Product Change Notification / GBNG-19OFUL850

CCB 4409.001 Final Notice: Qualification of palladium coated copper with gold flash (CuPdAu) bond wire for Atmel AT80C51RD2-RLTUM and AT80C51RD2-RLRUM catalog part numbers (CPN) available in 44L LQFP (10x10x1.4mm) package using 236x236 mils lead frame paddle size at ANAP assembly site.

PRE AND POST CHANGE SUMMARY

CCB 4409.001

Pre Change

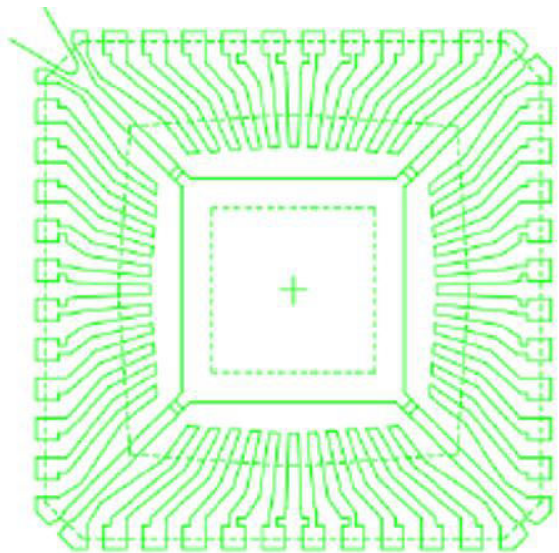
Strip Density	HDLF High Density Lead frame
LF Paddle Sie	177x177 mils
DAP Surface Prep	Double Ring Ag
Backside Dimple	Yes

Post Change

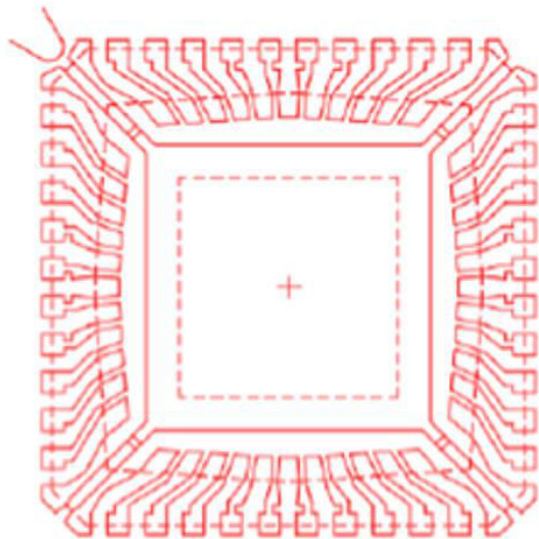
Strip Density	VHDLF Very High Density Lead frame
LF Paddle Sie	236x236 mils
DAP Surface Prep	Double Ring Ag
Backside Dimple	Yes
